DOCUMENT CHANGE REQUEST

DCR number 335 Changes required for: General

Title: Transistors High Power PNP, based on type BUX78

Number: 5204/006

Maximum Safe Operating Area Graph

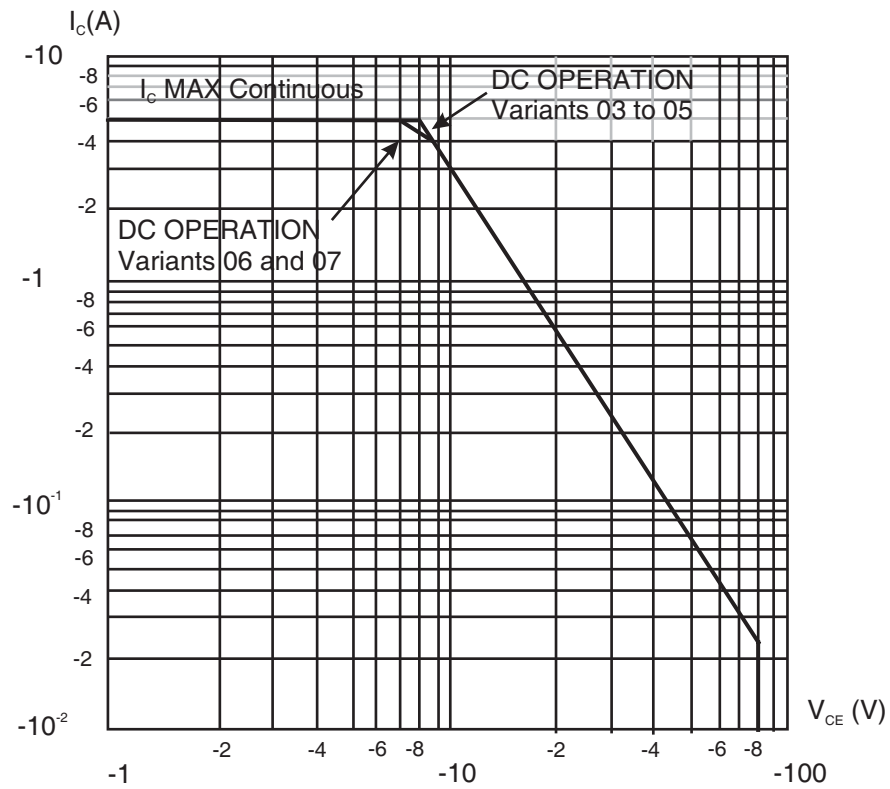
6. Figure 1(b) Forward Bias Safe Operating Area (Continuous DC) amended and moved to be a note in the Maximum Ratings table.
7. Para. 4.3.2 Weight requirements moved to Component Type Variants table.

4. Safe Operating Area applies as follows:

1.7 PHYSICAL DIMENSIONS AND TERMINAL IDENTIFICATION

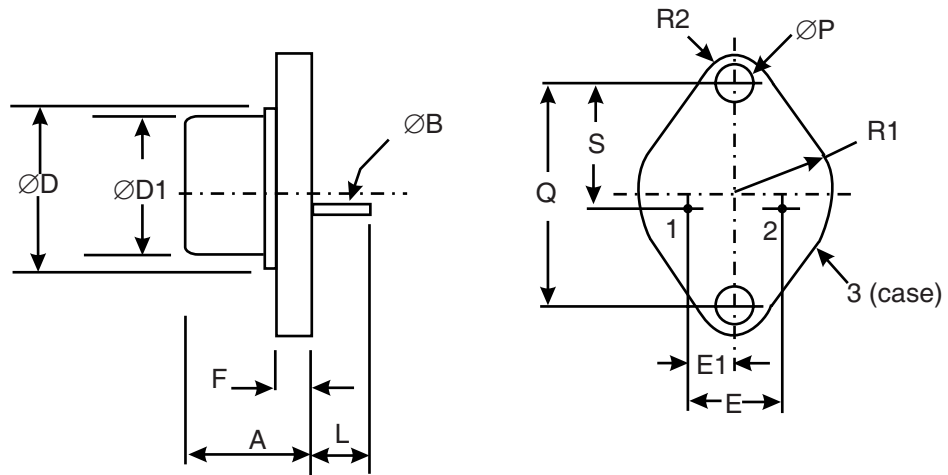
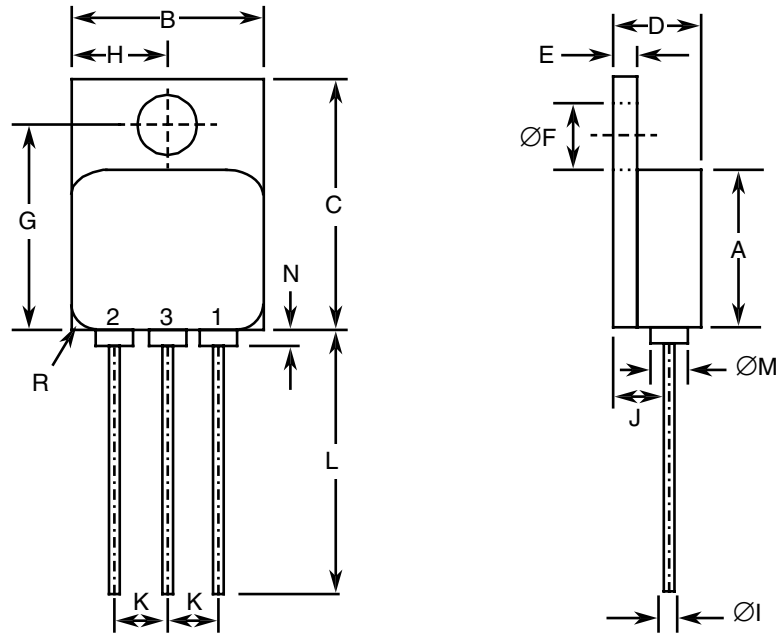
8. Figure 2 re-named "Physical Dimensions and Terminal Identification"; Figure 2(a) amended to reflect the TO-66 package currently supplied; Figure 2(b) amended to reflect the TO-257 package currently supplied. Consolidated notes added.

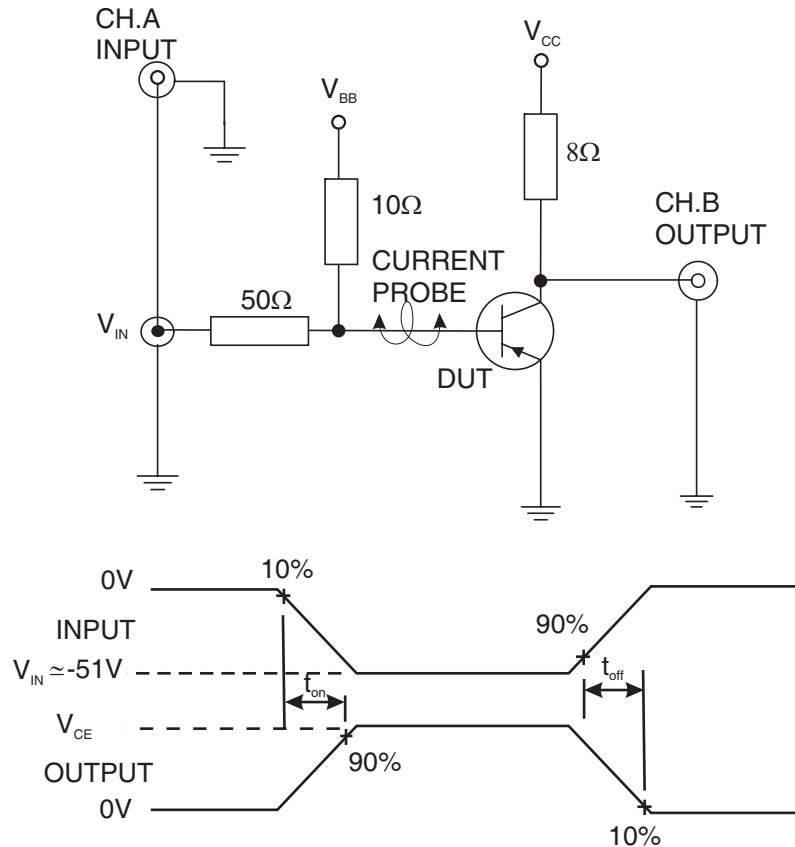
18. Table 2 and Figure 4: The Switching Times characteristics have been amended to reflect the new format.
19. Table 3, Characteristic "D.C. Forward Current Transfer Ratio 4" has been changed to "Forward-Current Transfer Ratio 4".
